Countries:	CANADA, UNITED STATES	Document ID:	IK1600227
Availability:	ISIS, IsSIR	Revision:	5
Major System:	CAB / SLEEPER / HOOD	Created:	7/13/2017
Current Language:	English	Last Modified:	7/31/2018
Other Languages:	NONE	Author:	Steven Bautz
Viewed:	1203

Title: Loose, Missing, or Damaged Glass in the LT Hood Mounted Mirror

Applies To: LT

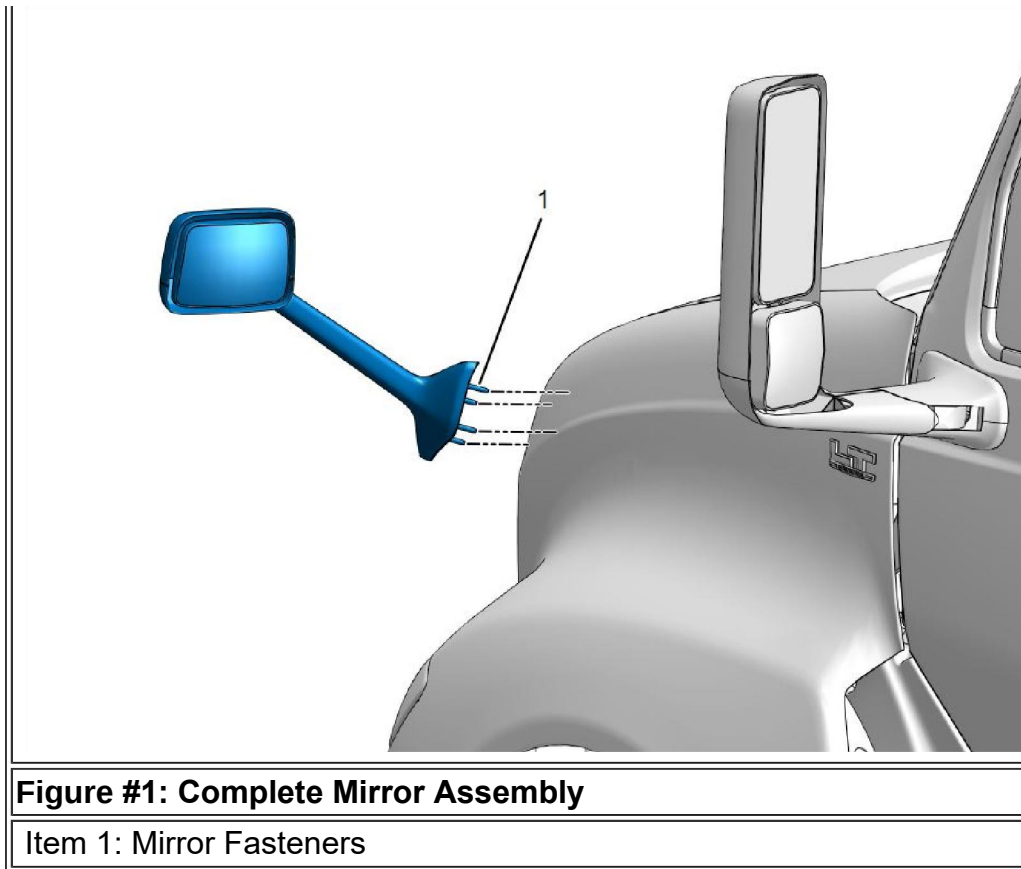
This document will guide the user through the inspection and replacement of the hood mounted mirror assembly. (Glass ONLY replacement is no longer serviceable.) As of November 2017, the design for the mirror glass attachment has changed to be permanently epoxied into the housing.

Inspect the condition of the mirror assembly. If the mirror is either loose or missing, the complete mirror assembly (Head & Arm) will need to be replaced.

Note: The replacement mirror assemblies have the glass epoxied in place. Going forward all LT hood mirror glass panels will not be serviceable separately. The entire mirror assembly (Head & Arm) will need to be replaced.

1. Open hood to gain access to the the mirror assembly mounting hardware.
2. Remove 4 fasteners (Figure 1, item 1).

3. Remove complete mirror assembly from vehicle taking care not to damage top coat paint.
4. Reinstall new mirror and torque fasteners to 9-12 ft-lb (12.2 - 16.2 Nm)
5. Close and relatch hood. Readjust mirror glass as needed.
